Docket Number:	23-OPT-01
Project Title:	Fountain Wind Project
TN #:	253307
Document Title:	Jim Wiegand Comments - Comments Against Fountain Wind #6
Description:	N/A
Filer:	System
Organization:	Jim Wiegand
Submitter Role:	Public
Submission Date:	11/27/2023 9:24:01 AM
Docketed Date:	11/27/2023

Comments Against Fountain Wind #6

Comments on the Humboldt Wind Project Draft Environmental Impact Report

Figure No. 5
 Title: Aerial Nest Survey Tracks

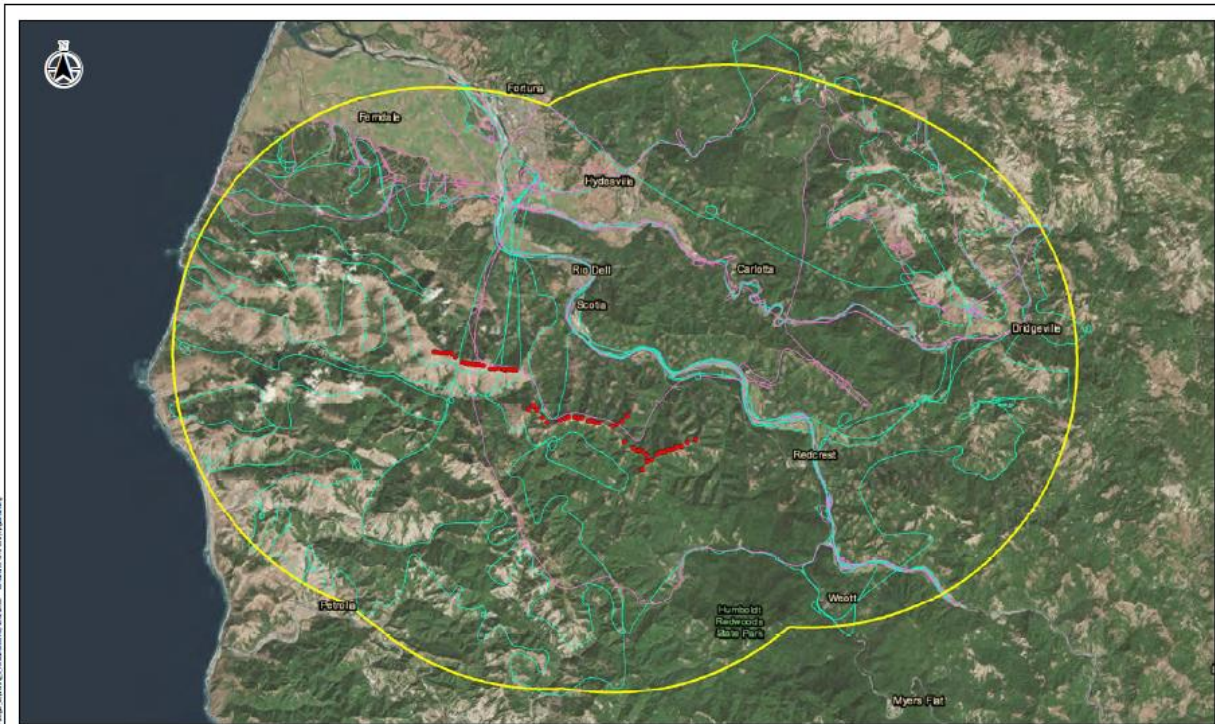
But these Stantec helicopter surveys were also poorly done. While these flight patterns shown in the DEIR would probably be suitable for an open desert area like Nevada. They are not suitable for this forested project site. There are huge flight pattern gaps that are over than ten miles wide in this terrain. In this habitat, if the proper flight angle is not taken, a helicopter could miss an eagle nest only ¼ mile away. This is especially true for a golden eagle's nest.

In my analysis of the habitat around the project site on google earth imagery, I would have never conducted these eagle surveys like Stantec did. It is also my opinion that these flight routes were staged. The eagle nest surveys also failed to take a simple boat trip down the river to document bald eagle behavior that could help observers verify a nest, nesting activity and or a nesting territory.

- Legend**
- Proposed Representative Wind Turbine Locations
 - Radar Survey Location
 - 1.4 km Radar Range Limit
 - ▨ Radar Blind Spot
 - Initial Vertical Radar Antenna Alignment

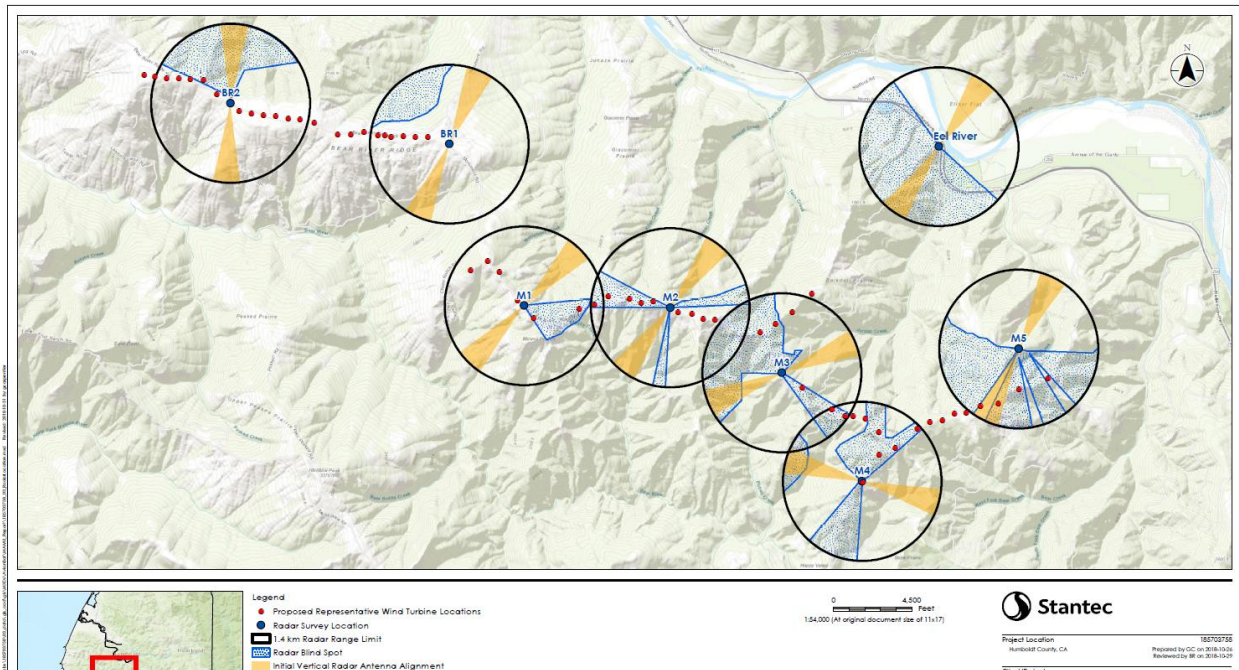
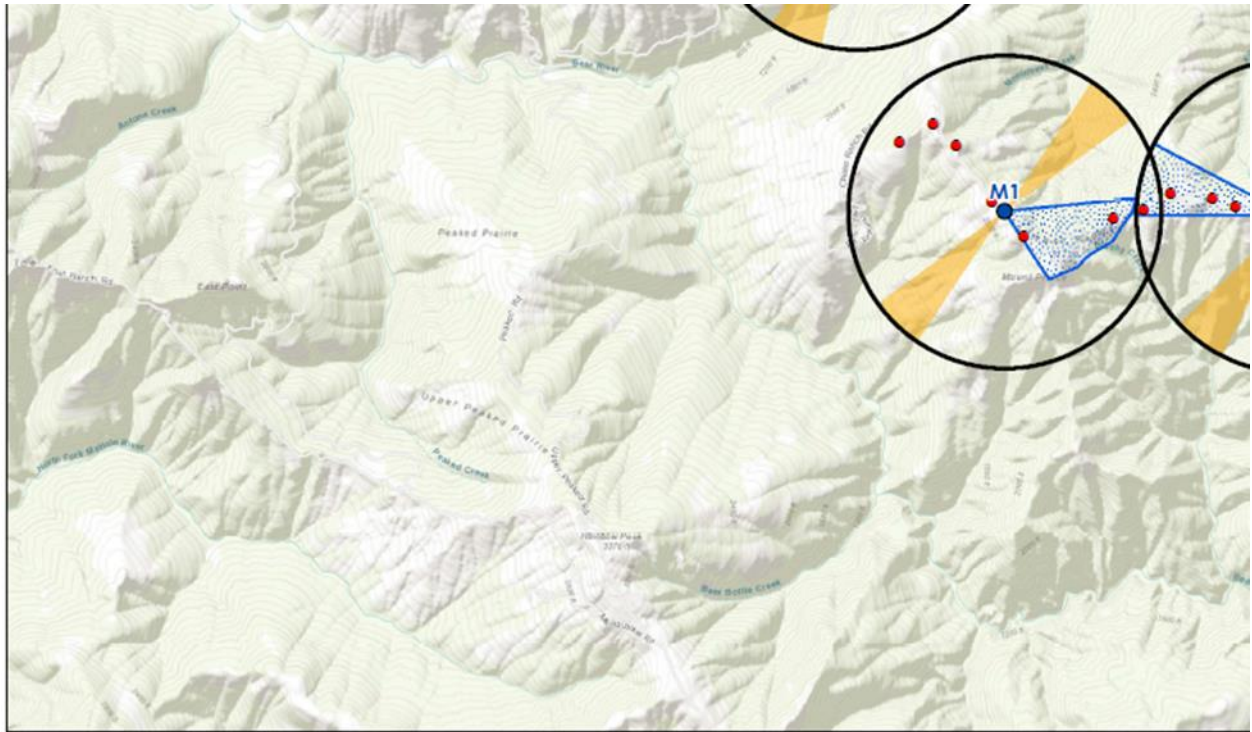
Look close at The DEIR images and study the all huge blind spots. With all these blind spots, there is little radar coverage on most of these turbine sites. There is also no complete vertical and horizontal radar coverage for this project's turbine rotor sweep zones (see VSR and HSR image). This vital information is missing not only for these Marbled murrelets but for the a multitude of other species as well. How many thousands of total targets were seen in this radar study, only to be dismissed as not being murrelets?

“Three observed ridge crossing flights **did not have any vertical data available**”

“Flight altitude, **when available**, for targets observed or projected to have crossed the ridge.”

“**With some exceptions**, most murrelet activity that we observed was generally traveling parallel to the project area”

Table 6. Summary of survey effort for small bird use counts conducted at the Humboldt Wind Energy Project, Humboldt County, California, April 3–October 26, 2018.

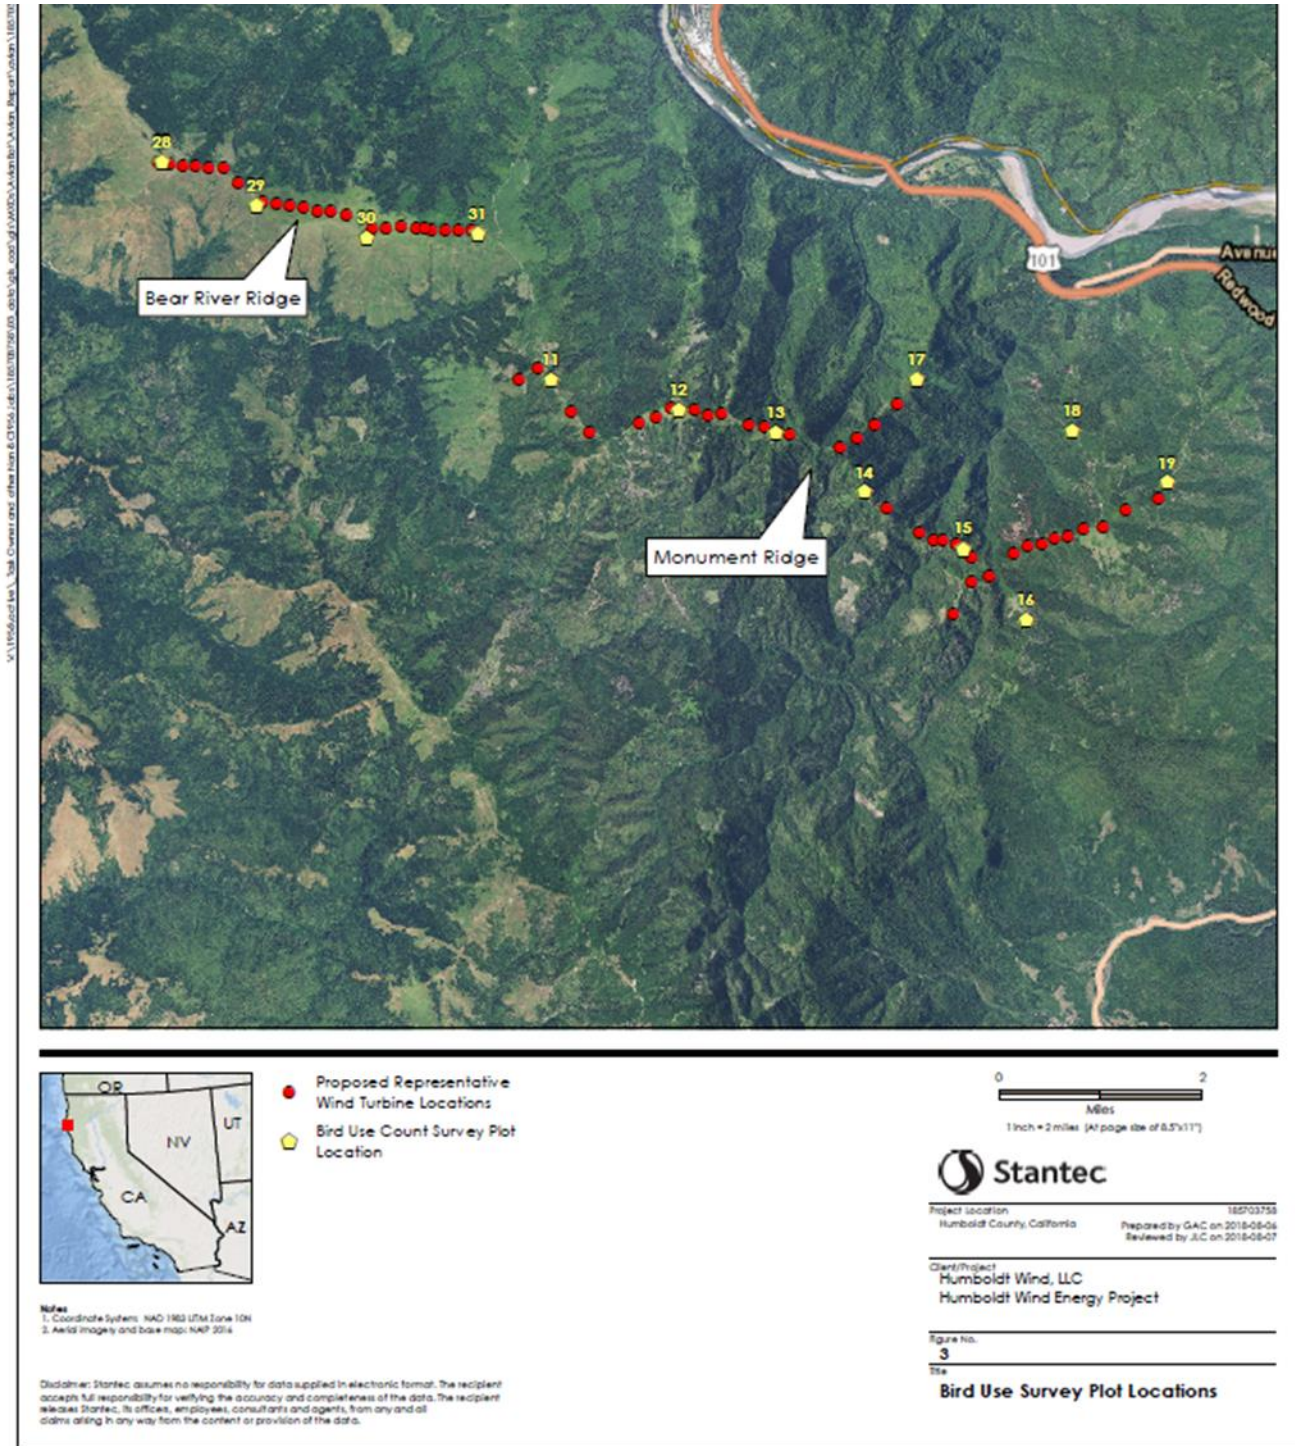
The summary of bird use counts shown below show minimal effort and a very poor effort went into these surveys. Look at all the important months that were missed for important survey locations during migration periods.

6.0 RISK ASSESSMENT-

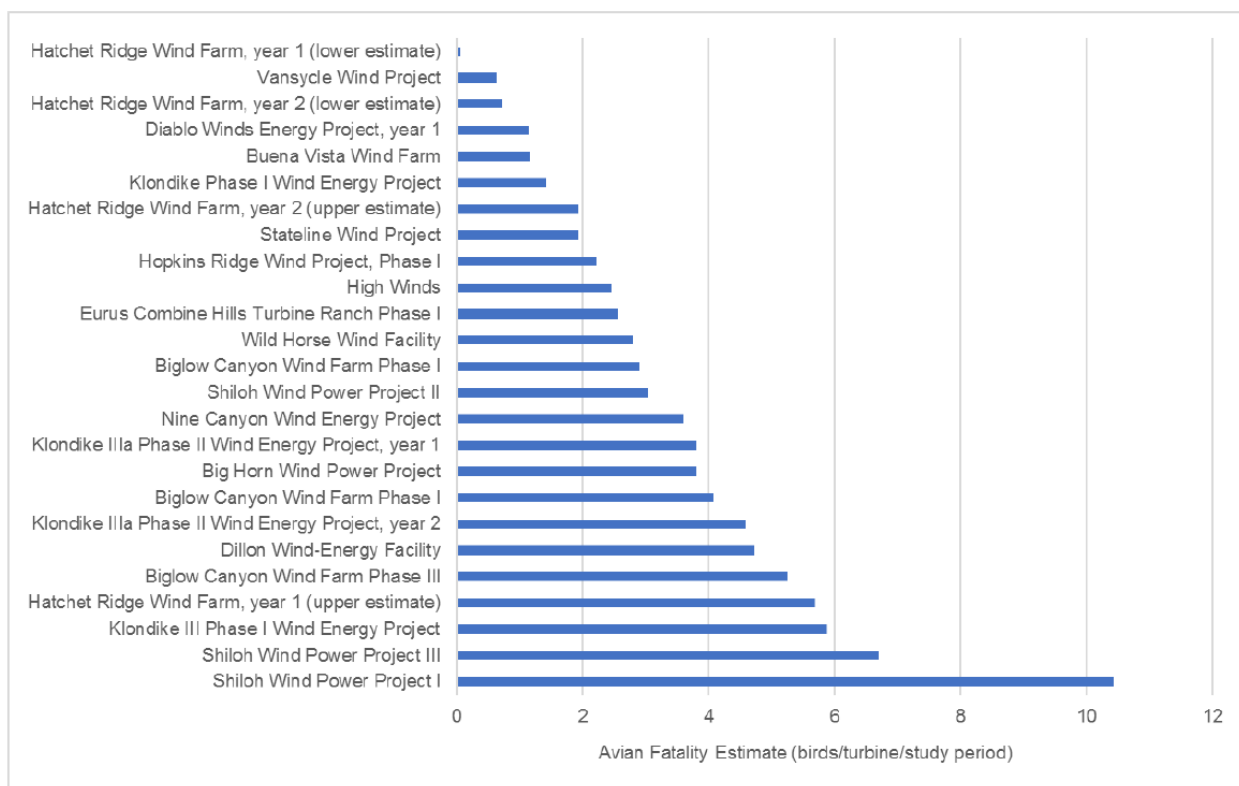
For their risk assessment, Stantec has presented Humboldt County with the results from these regional mortality studies (see image) in the DEIR. But none of these studies are scientific or even remotely accurate because of the wind industry study methodologies for these reported numbers. Hatchet Ridge is showing the lowest mortality and the Shiloh I wind project is showing the highest mortality. I will discuss why neither of these studies are credible.

Stantec’s DEIR also does not mention that none of these wind farms location have near the bird numbers, number of bird species or the incredible bird migration activity as the Humboldt wind project location. Also not mentioned in this risk assessment is rotor sweep density per sq mile or that none these wind farms had 600 ft turbines with 74.5 meter blades spinning at 17 rpm or 297 mph.

Typical Stantec post construction mortality research

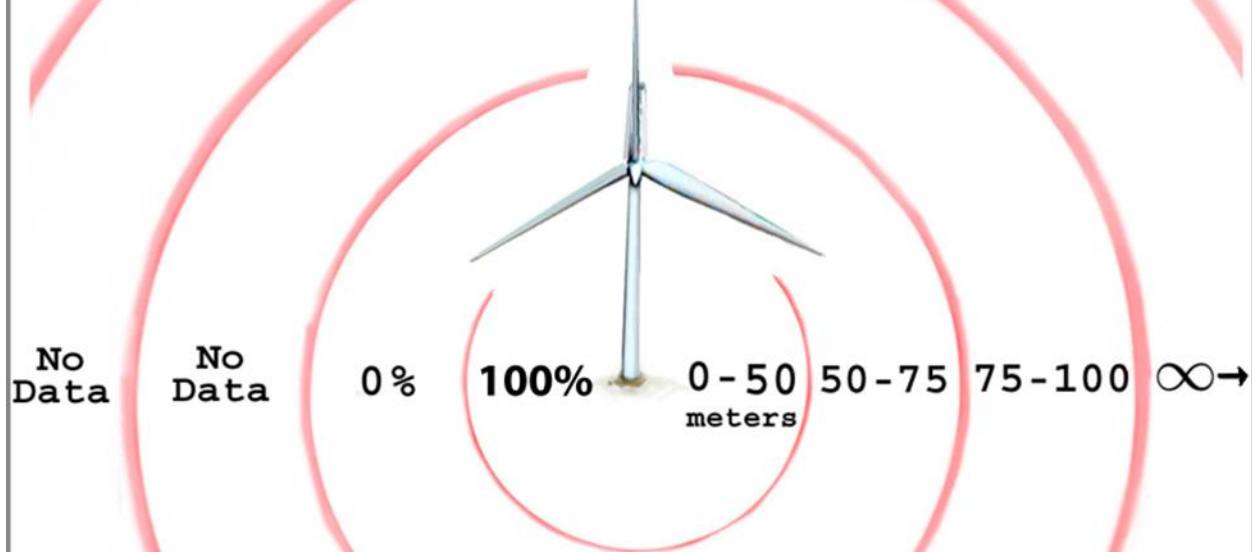
As bad these two examples of wind industry mortality research are, it gets even get worse. STANTEC's mortality research is even more ridiculous because they will conduct mortality studies out to 50 meters for 400 ft turbines with 50 meter blades. But they won't even search these entire 50 meters areas in wide open terrain. Instead formal searches include a small clear roadway and the little clear area around turbine bases. Stantec missed thousands of carcasses that landed outside their tiny search areas and did not account for carcasses out to 250 meters.

Birds and Bats reported from small portion of 0-50 meter designated search areas when most carcasses would be found in the huge area between 50 - 250 meters
